TRAILS AT ASPEN RIDGE FILING NO.2

EL PASO COUNTY, CO

ROADWAY & STORM IMPROVEMENT PLANS

FEBRUARY, 2020

ET KEY/ SIDEWALK EXHIBIT

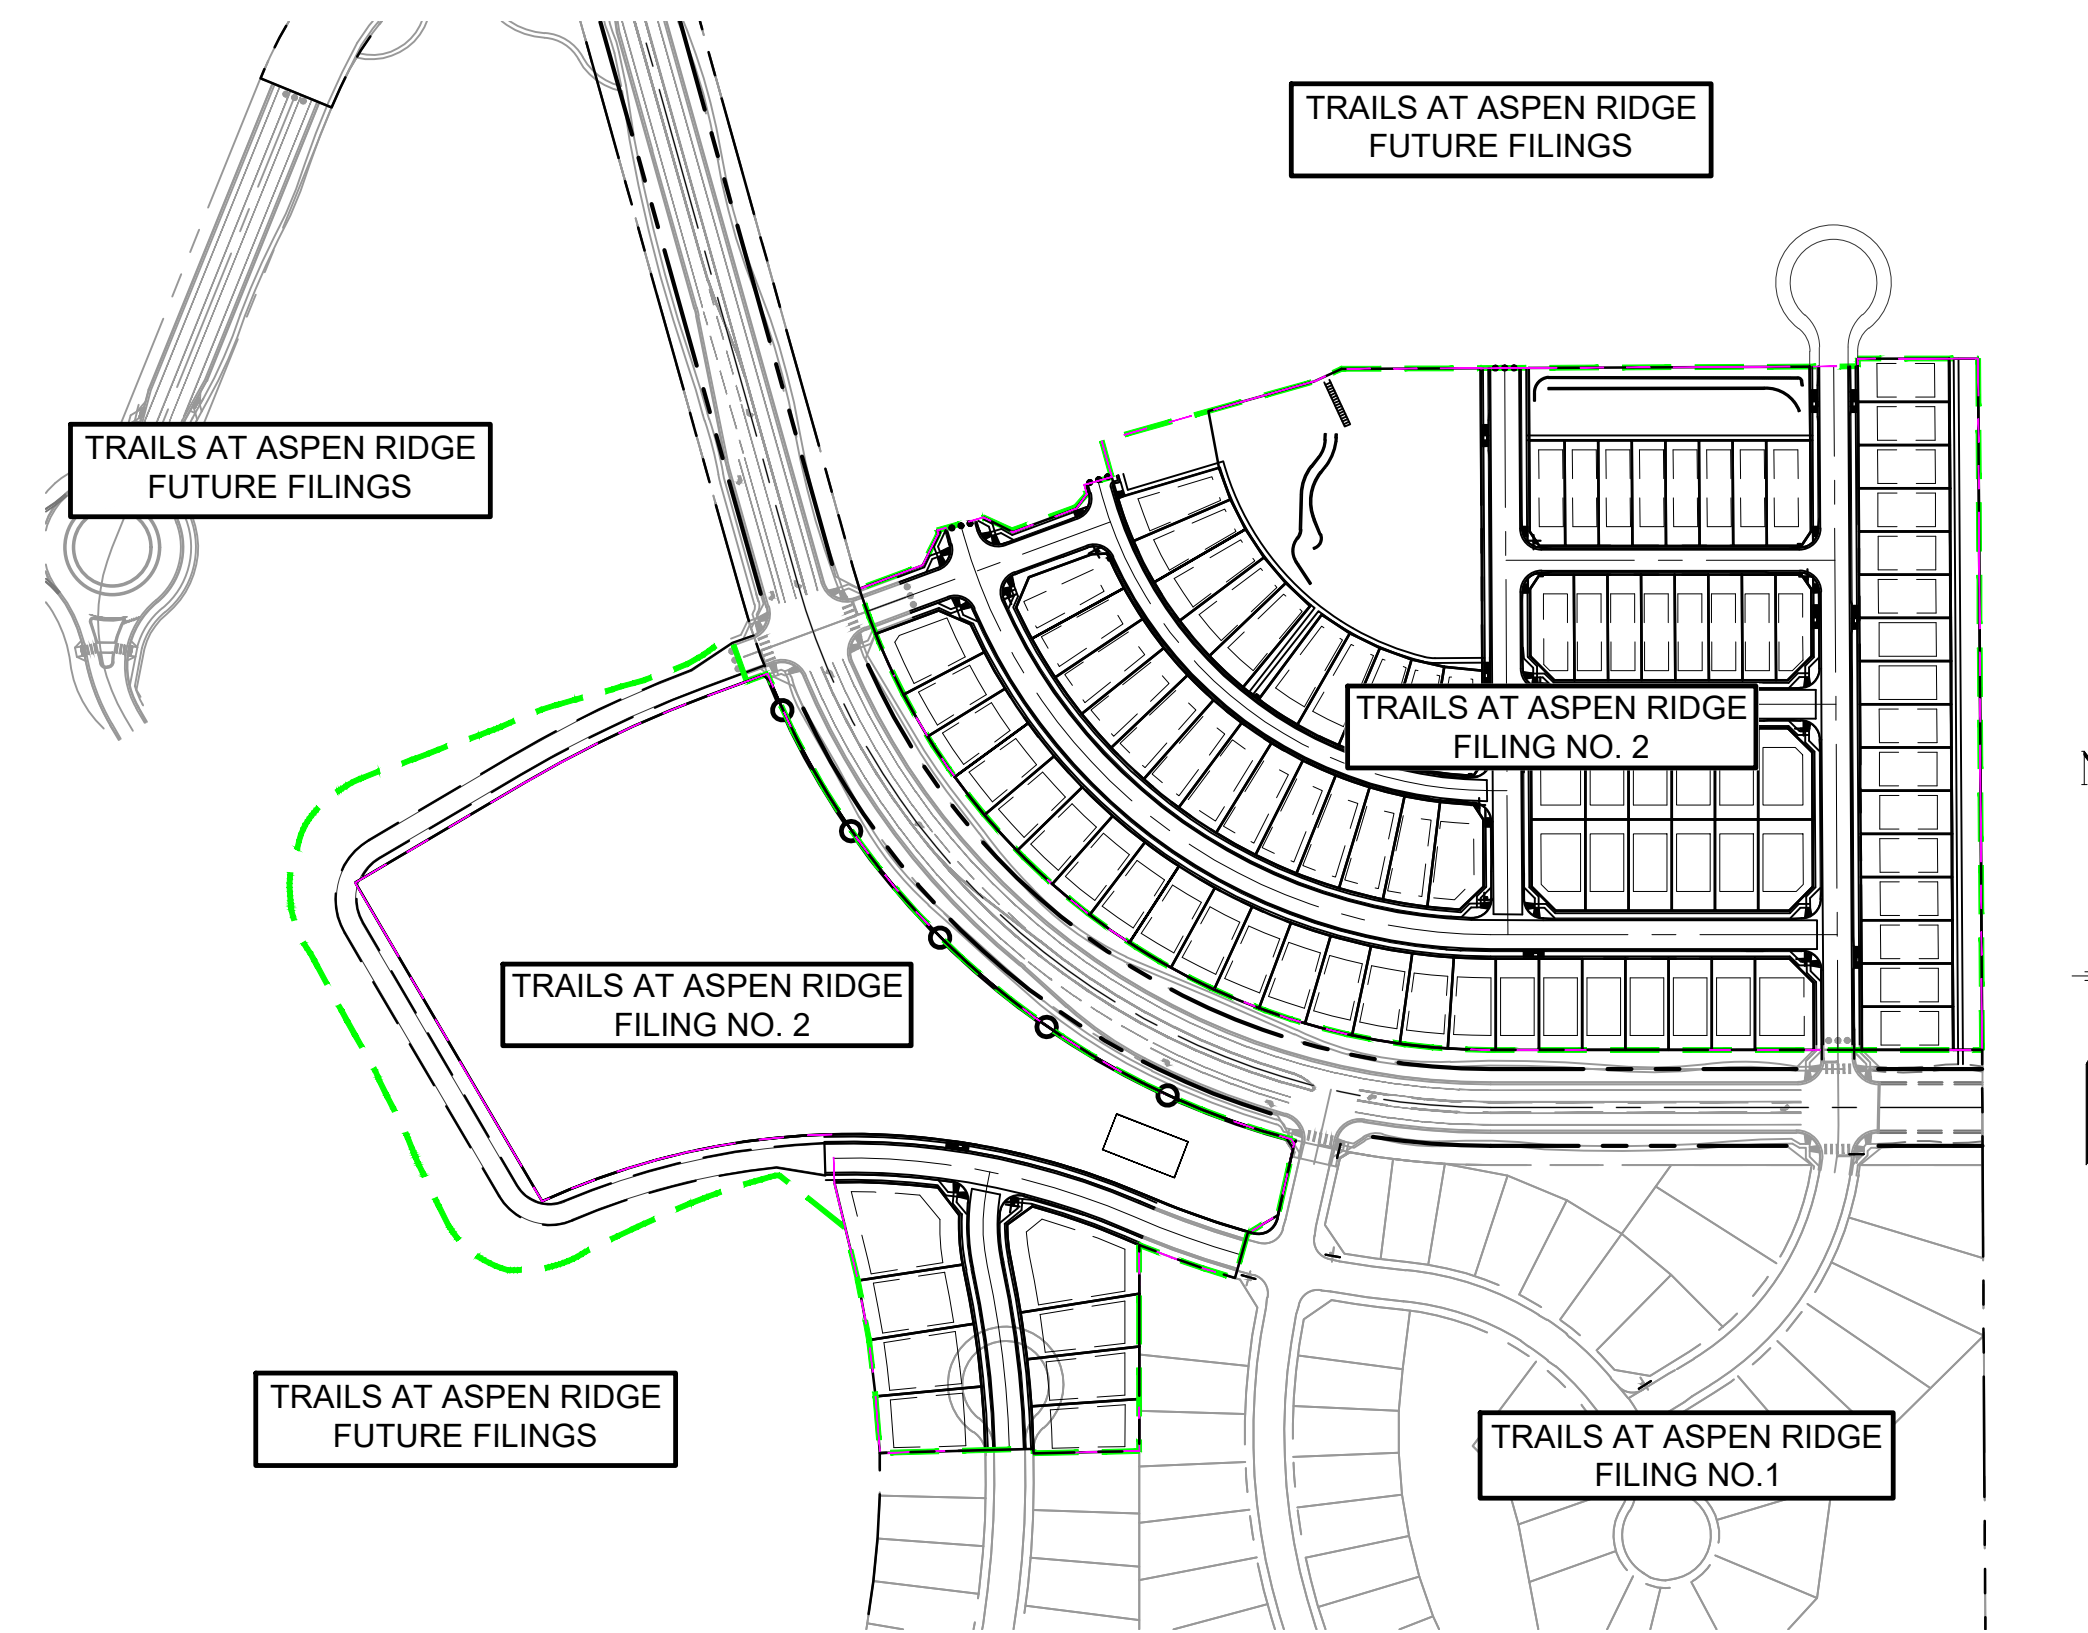
Add a sidewalk exhibit similar to Filing 1 sheet 5 of 72 (RDX1-B) showing sidewalk thickness.

TRAILS AT ASPEN RIDGE FILING NO. 2 ROADWAY & STORM IMPROVEMENT PLANS ROADWAY GENERAL NOTES. Includes designer, drafter, checker, scale, date issued, and drawing number information.

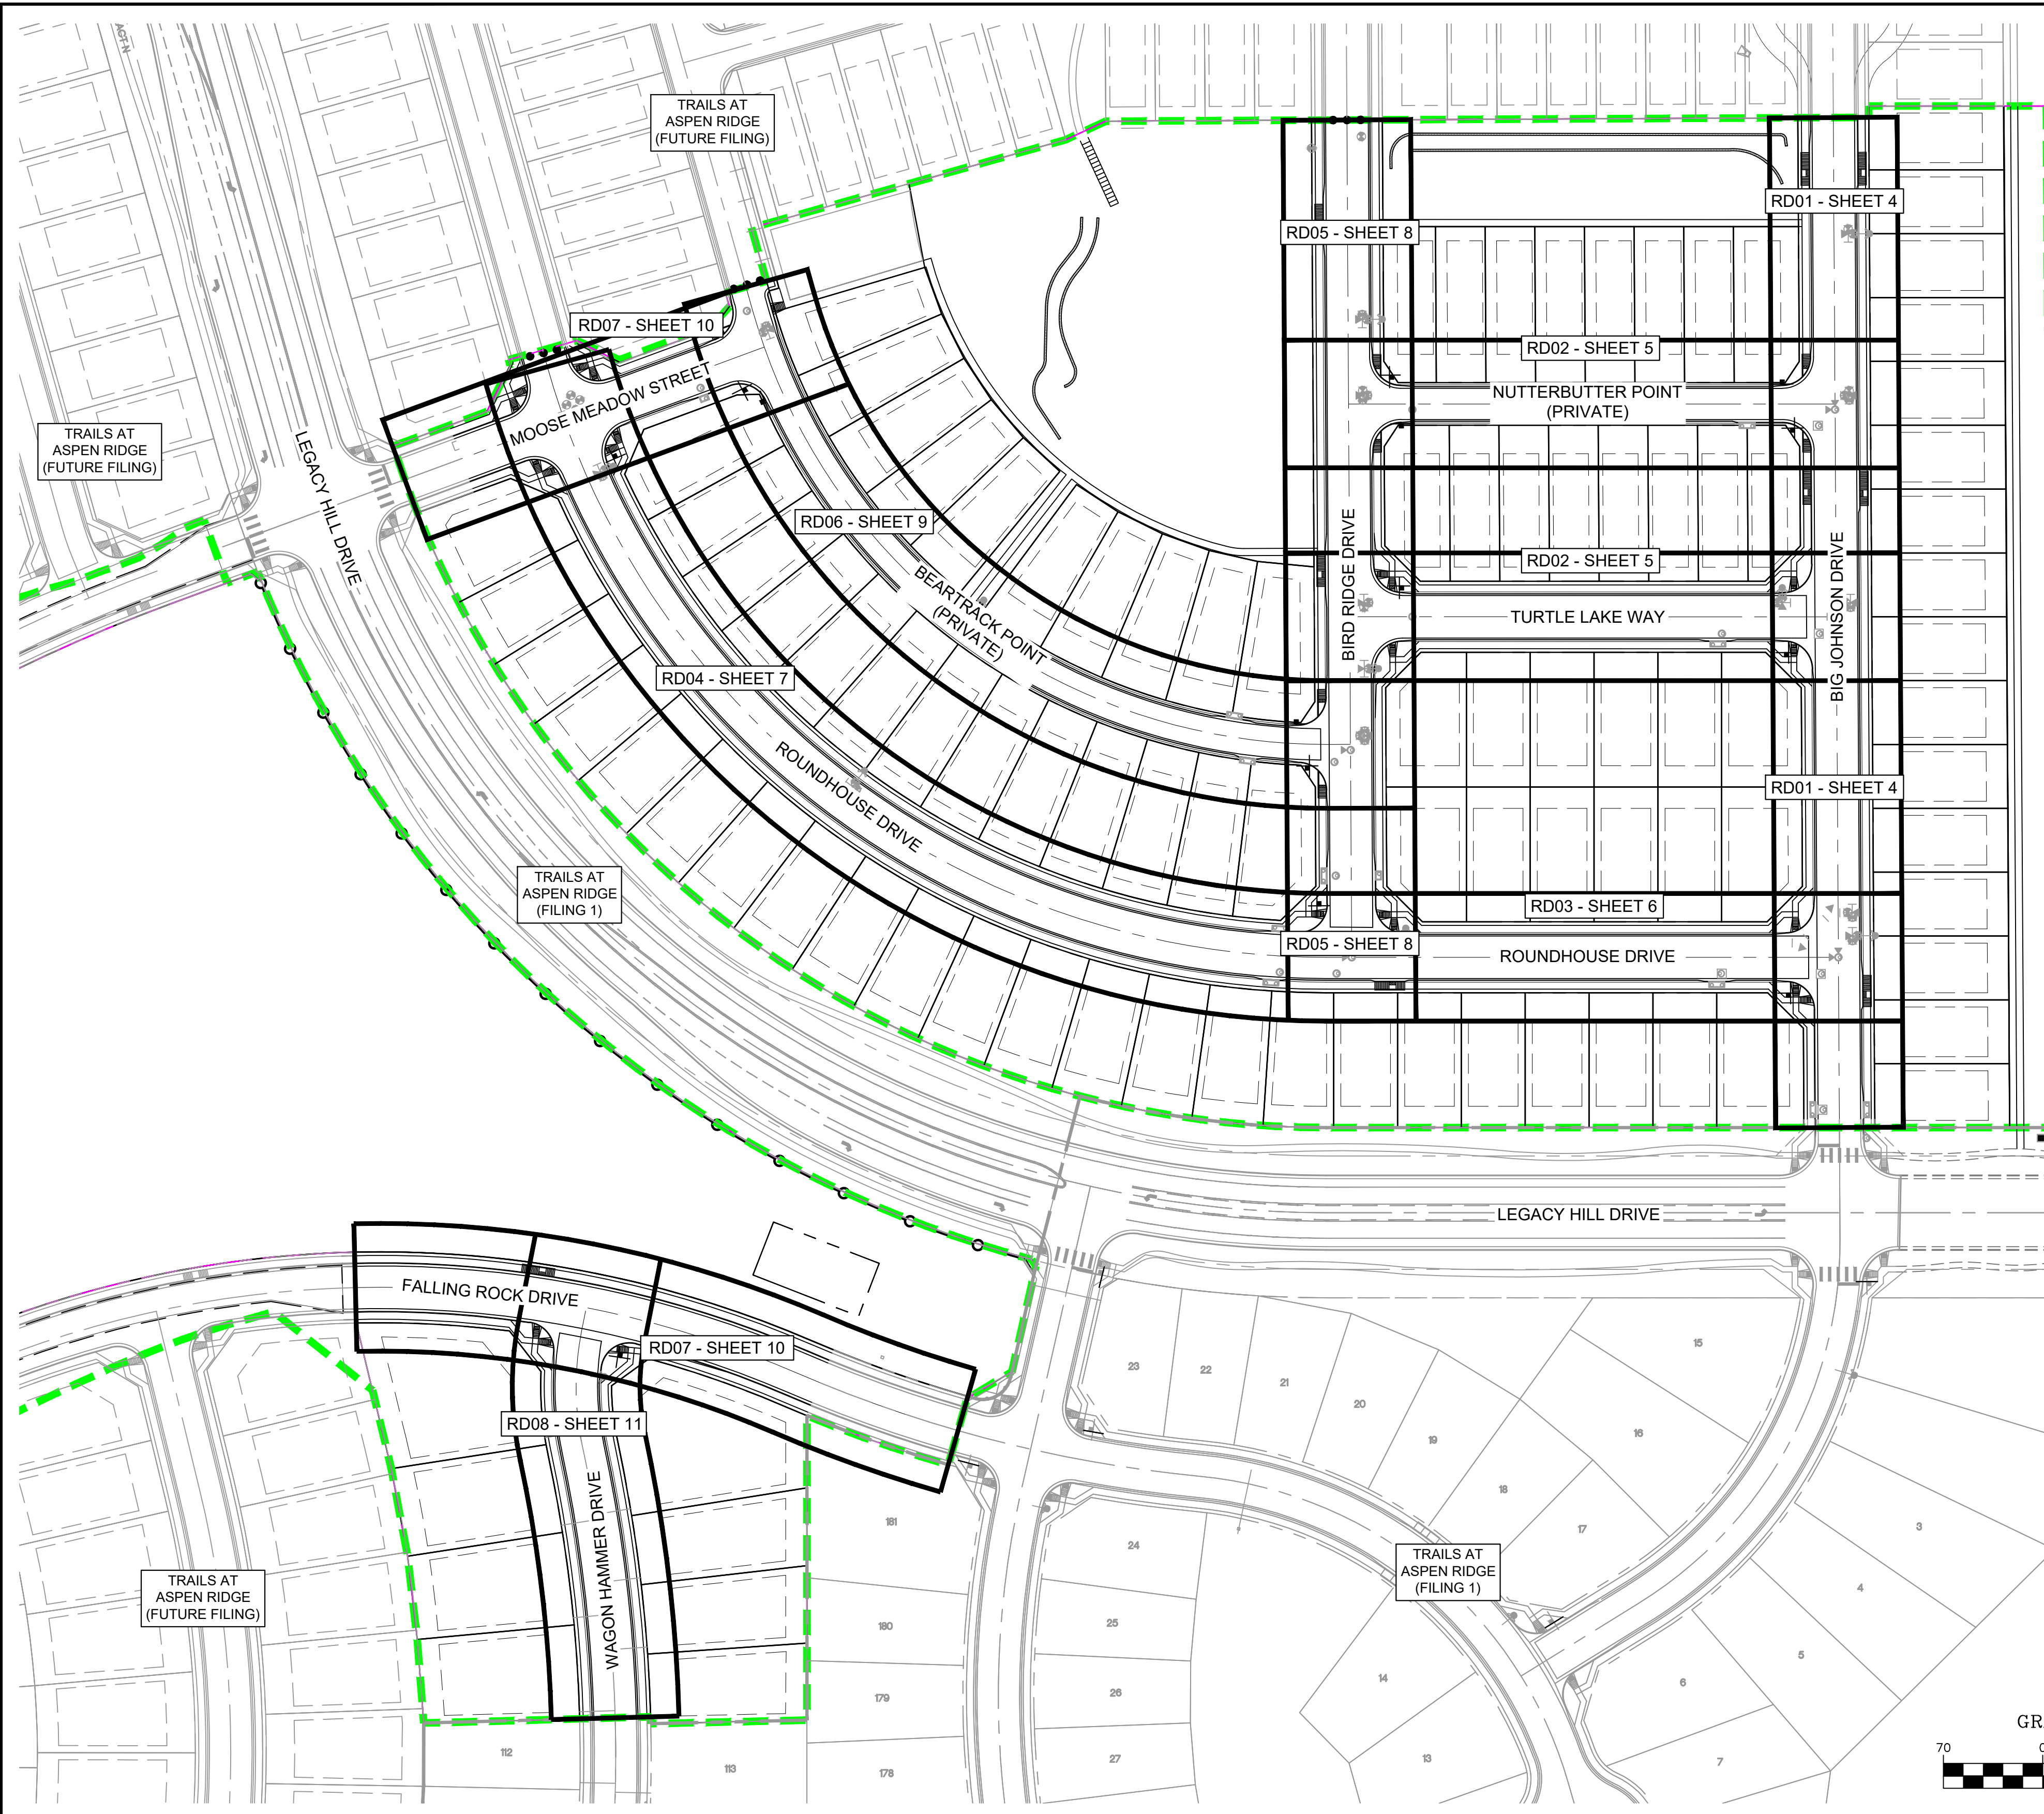
Revise to 5'. Unresolved.

RD00

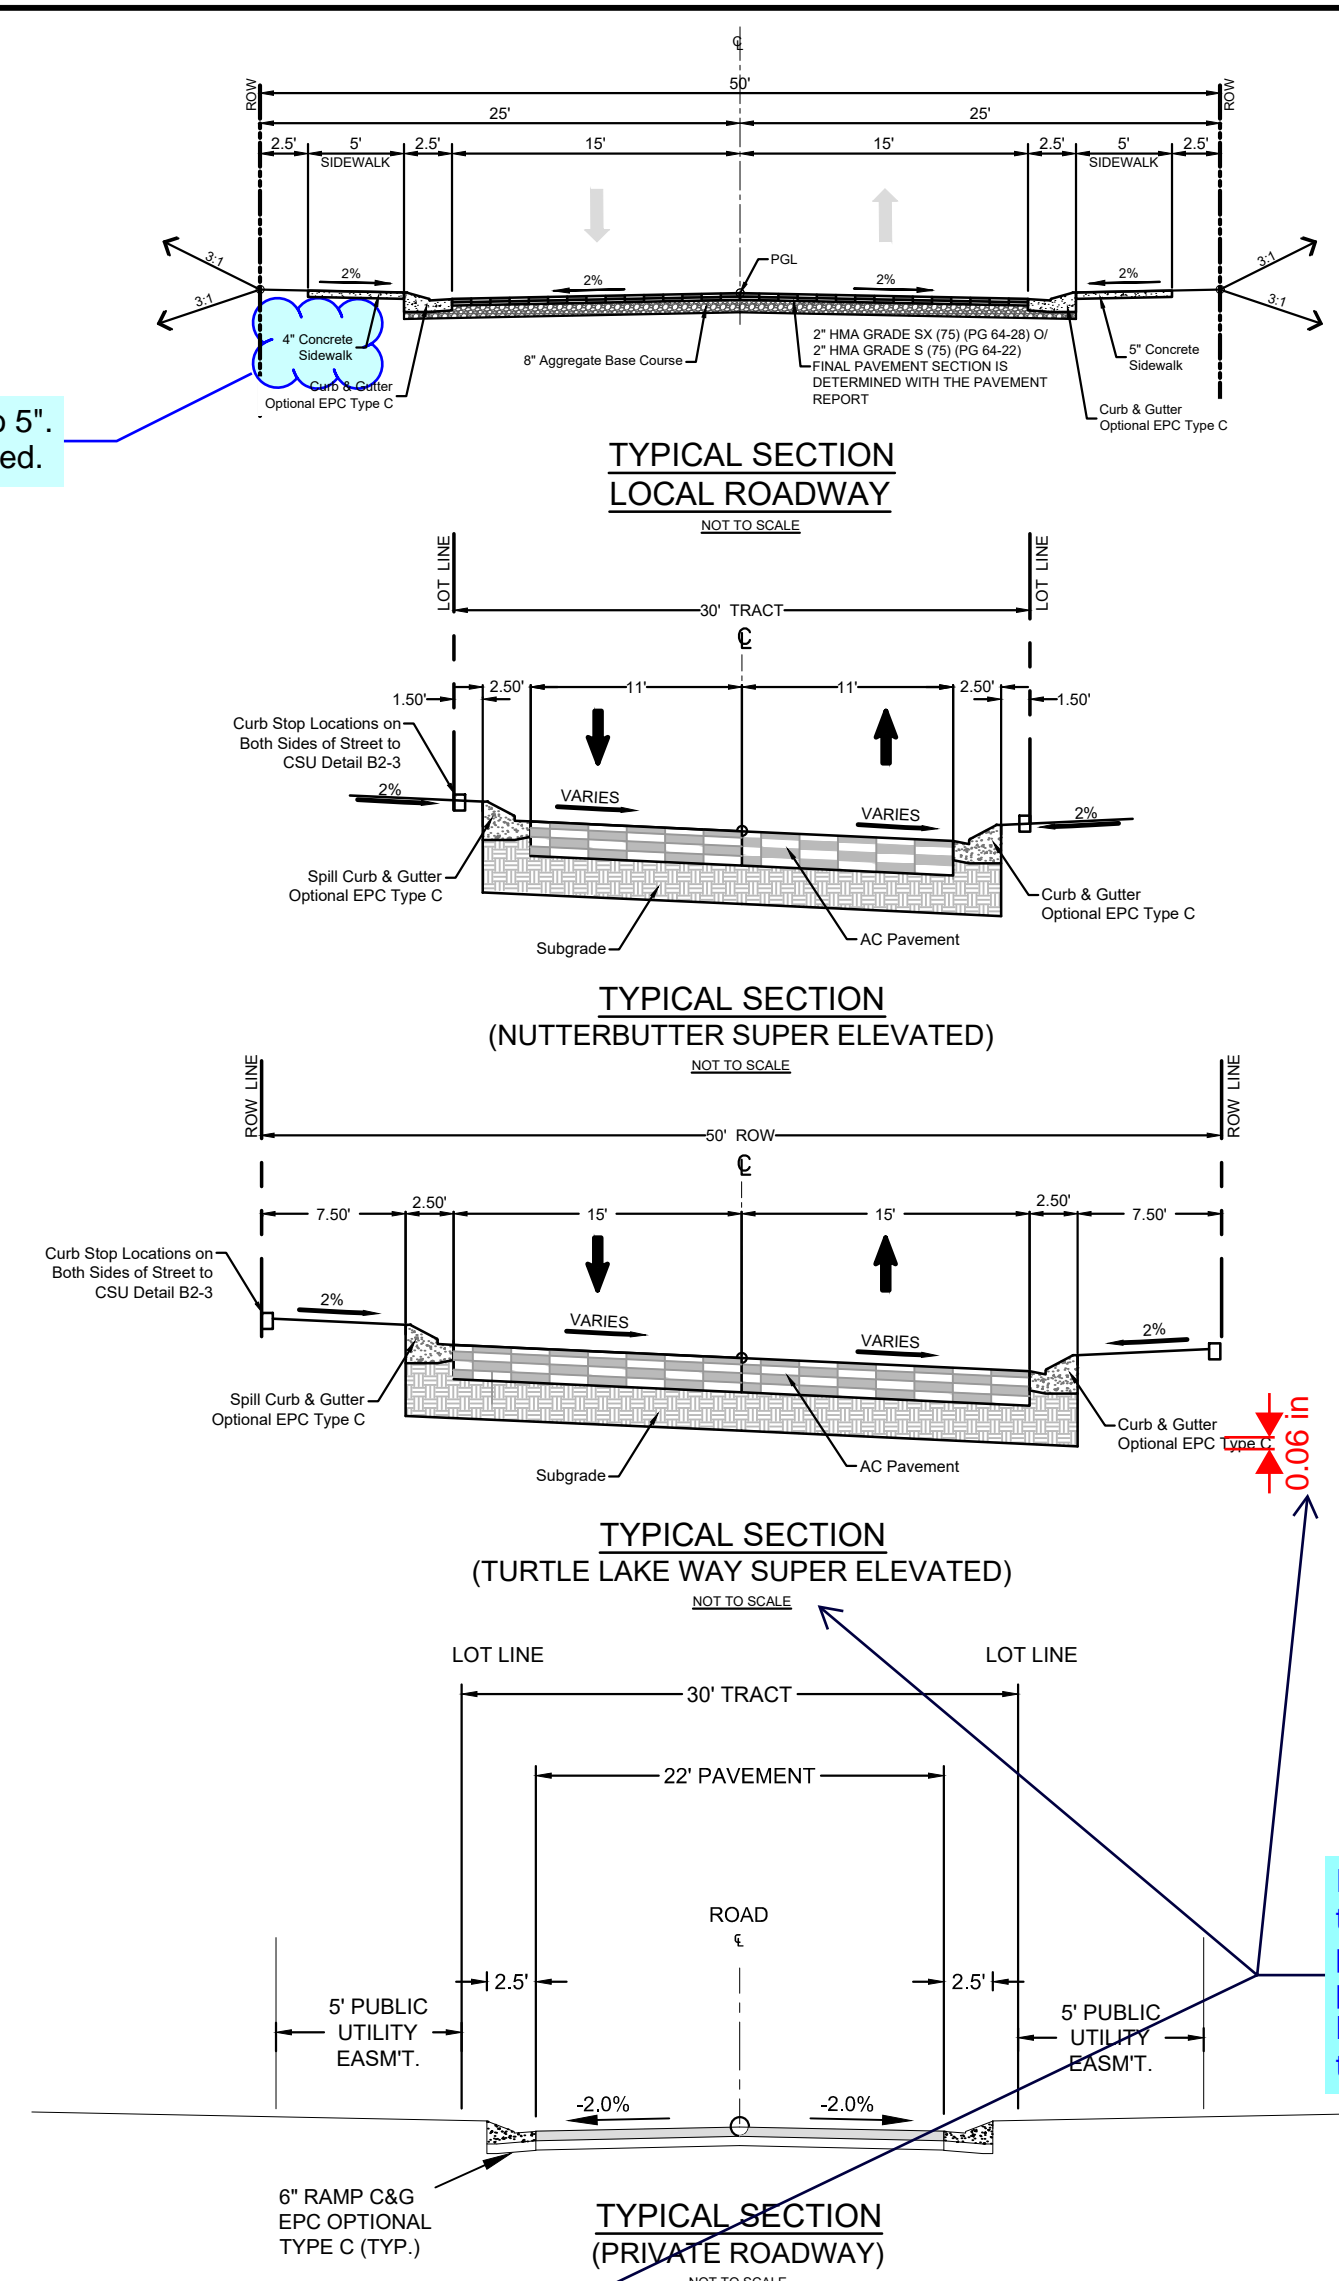
Increase text heights to be legible when printed as reduced plans on 11x17. Min text height = 0.10 typ.
